ANN ARBOR HISTORIC DISTRICT COMMISSION

Staff Report

ADDRESS: 218 N. Division Street, Application Number HDC22-1157

REPORT DATE: August 11, 2022

PHOTO BEFORE PROPOSED CHANGE

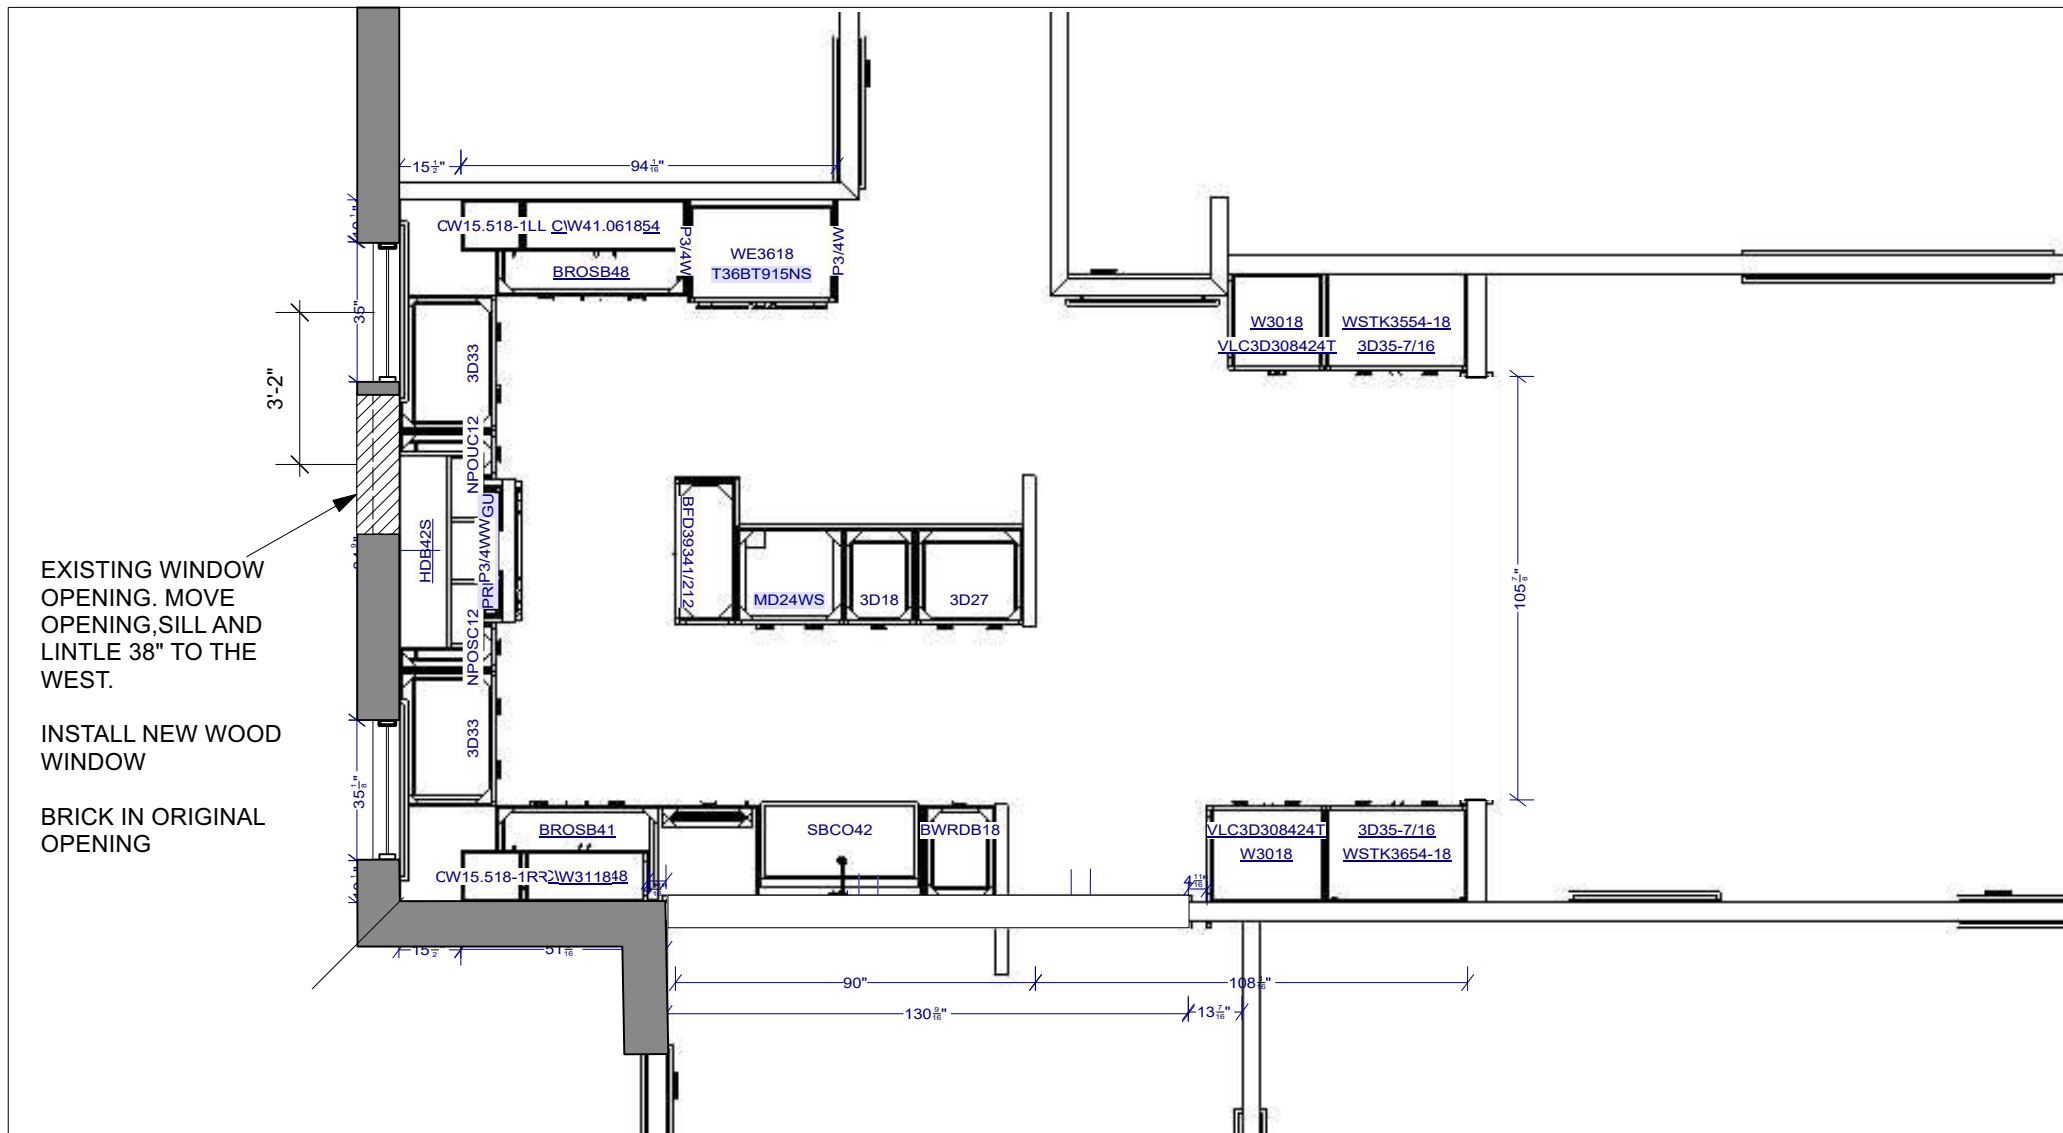
3. The window opening proposed to be moved is an opening that is original to the house. Looking at sheet 3 of the applicant's attachments, a missing window on the second floor would have been aligned with this window (the brick has obviously been infilled and patched). Moving the window as shown on sheet 4 brings it out of alignment with both the center window on the second floor and the missing window that was above its current location.

4. The historic character of the building is defined in large part by its symmetry, which would be diminished if this window were moved. Should the HDC decide it is appropriate to move the window, some record of its exact location should be made in the brick infill, possibly by inseting the perimeter brick or all of the infill by 2" or more.
